# PRELIMINARY DRAINAGE PLAN PUD/SP 21-006

## THE RIDGE AT LORSON RANCH

### Engineering Review

PCD-ENGINEERING REVIEW COMMENTS  
IN BLUE BOXES WITH BLUE TEXT

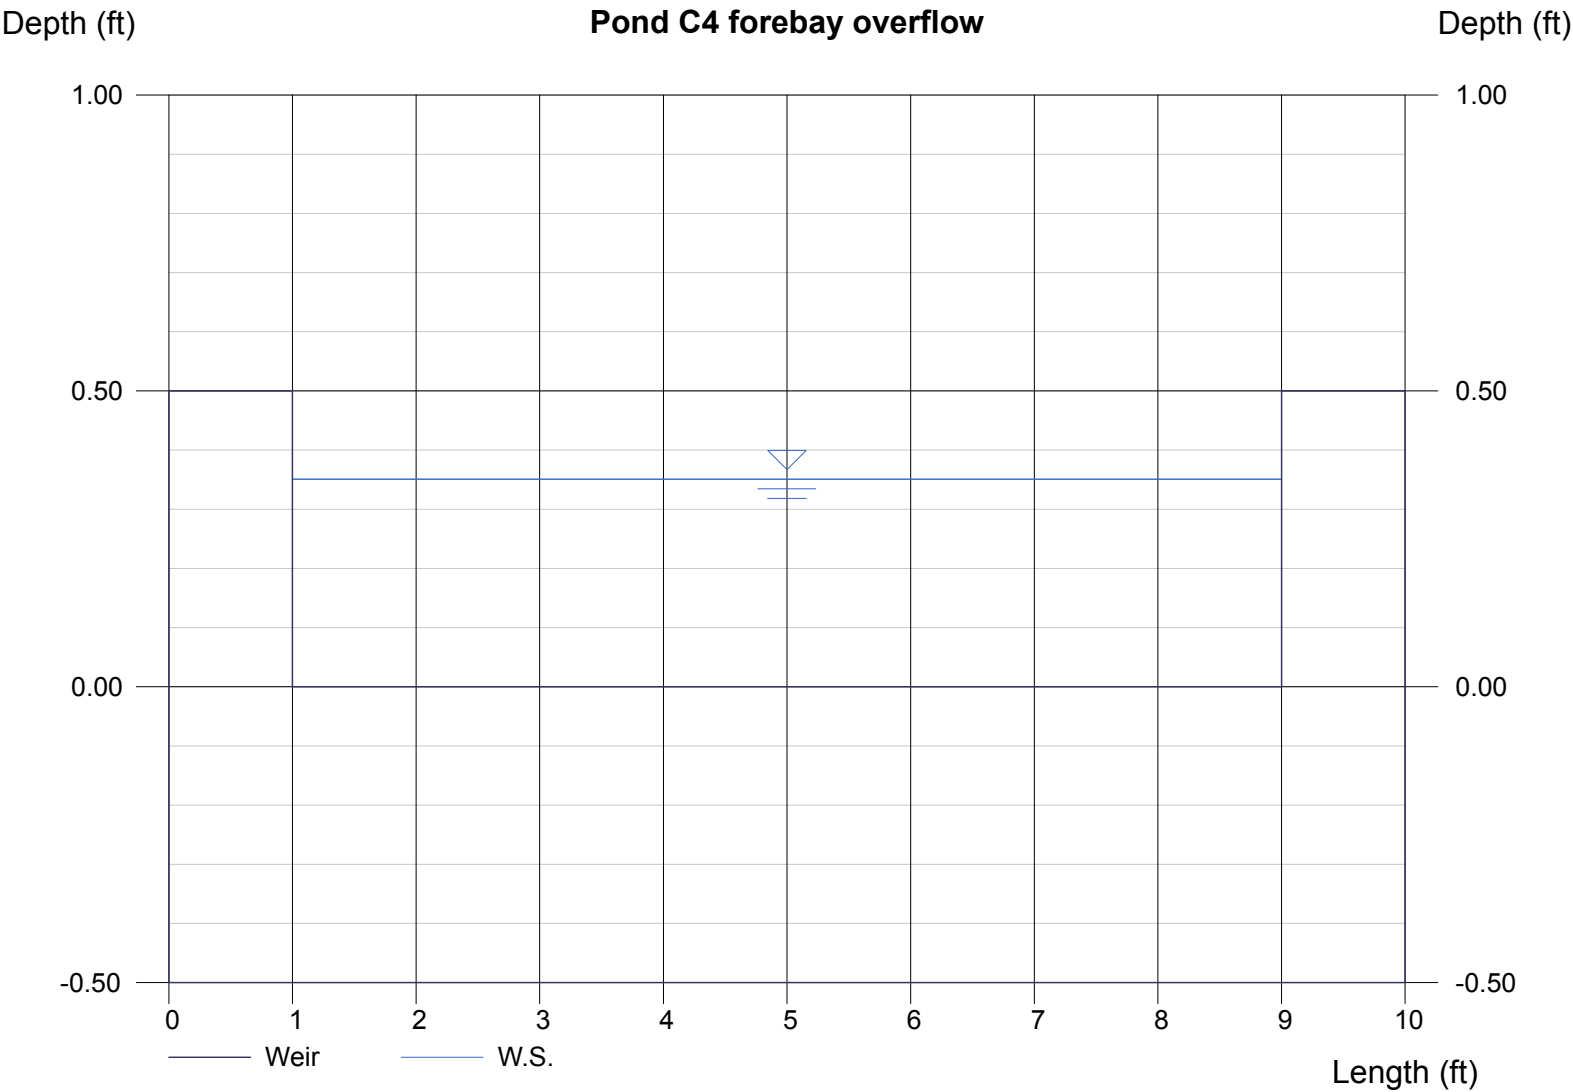
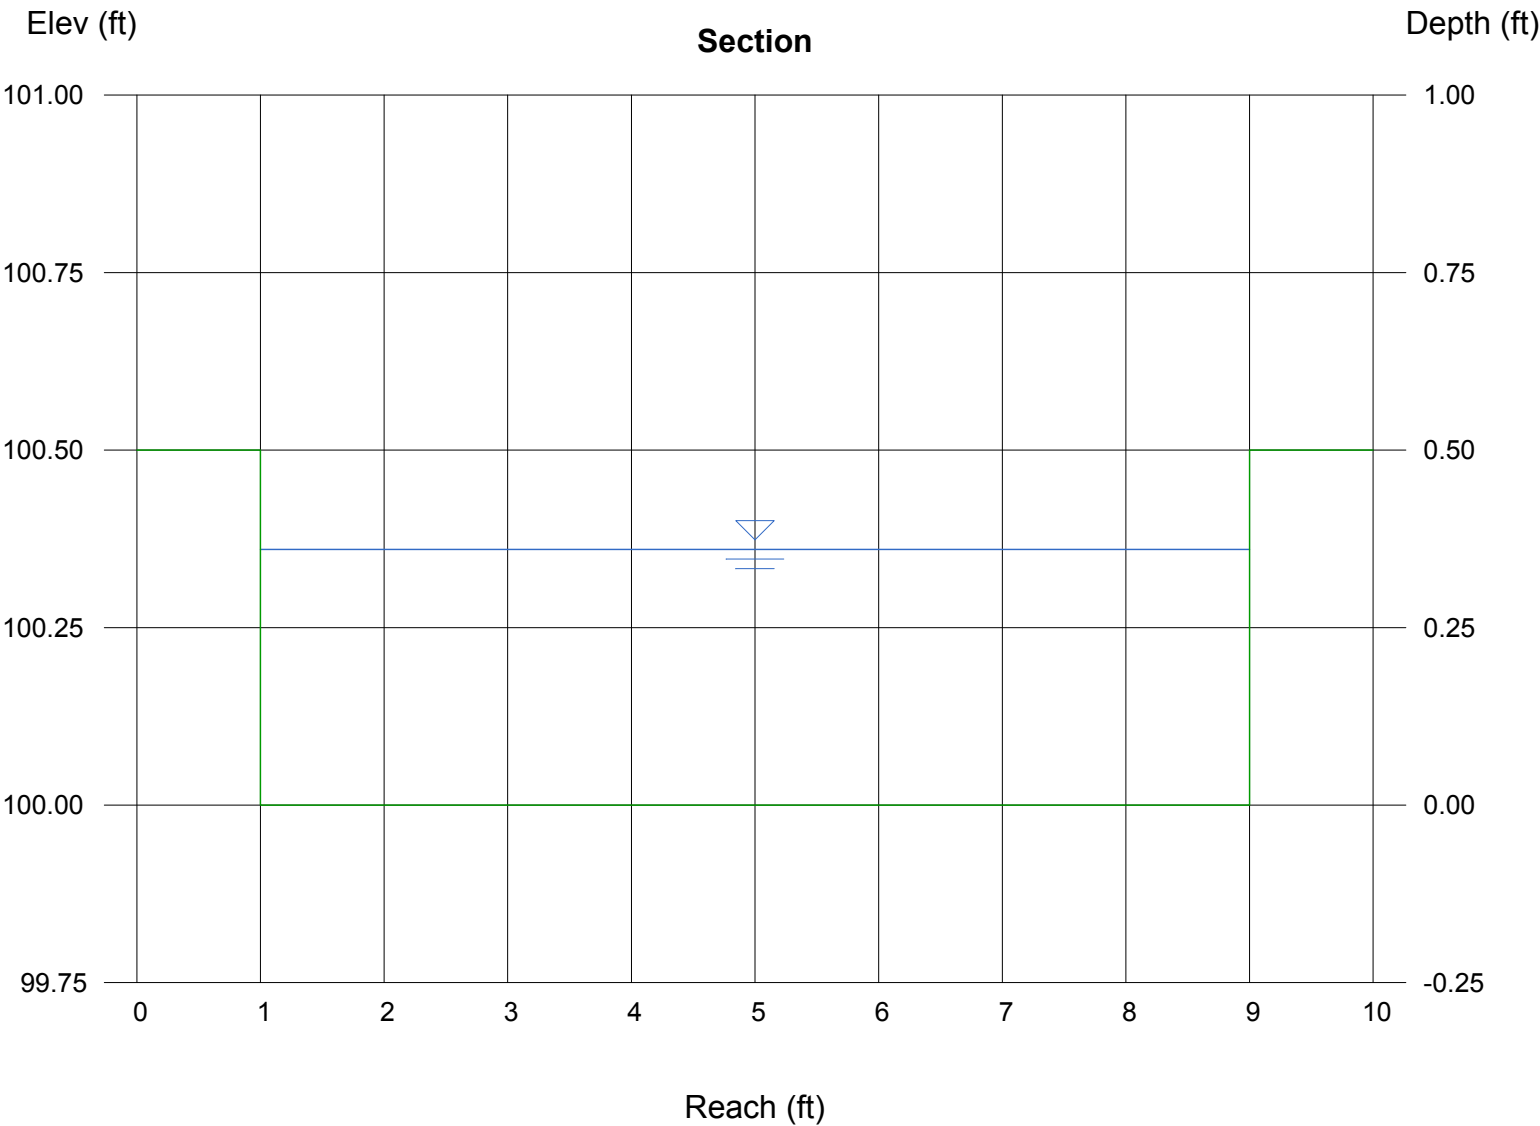
This should go from Plate --> Overflow Gate ---> Spillway. Revise.

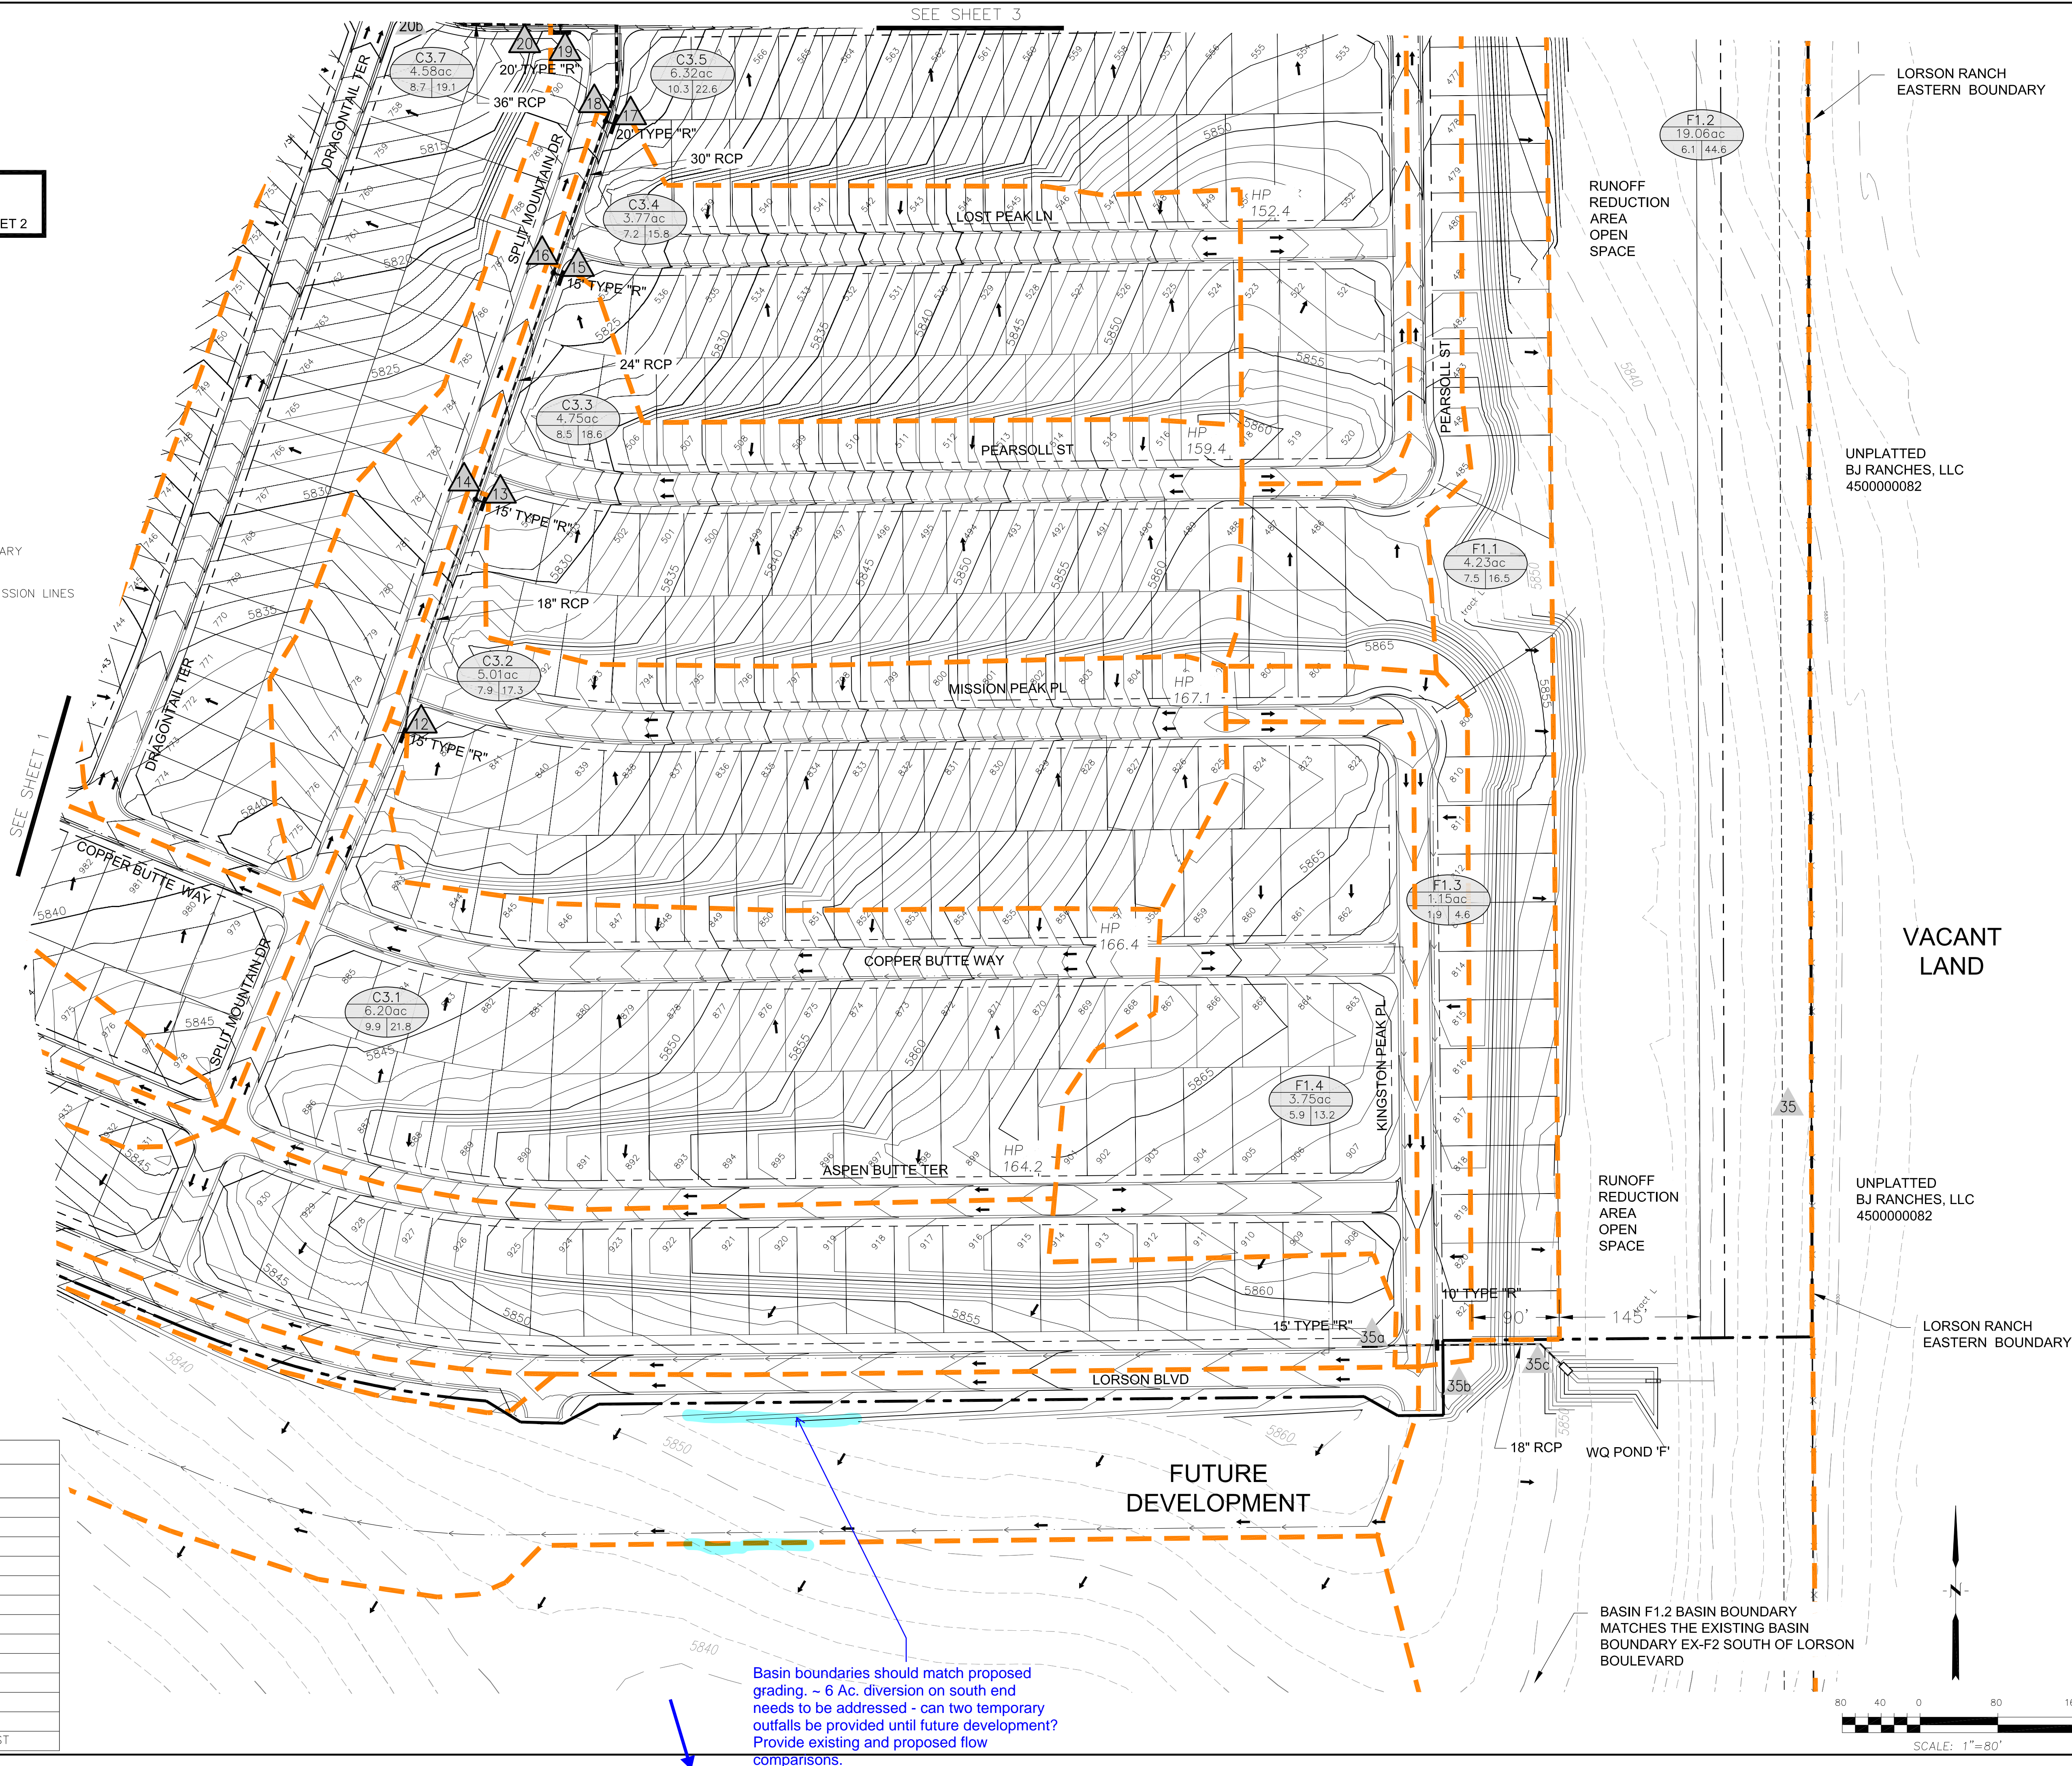
See comment on next sheet

Provide DP at south property line to compare existing and proposed flows

Basin boundaries should match proposed grading. ~ 6 Ac. diversion on south end needs to be addressed - can two temporary outfalls be provided until future development? Provide existing and proposed flow comparisons.
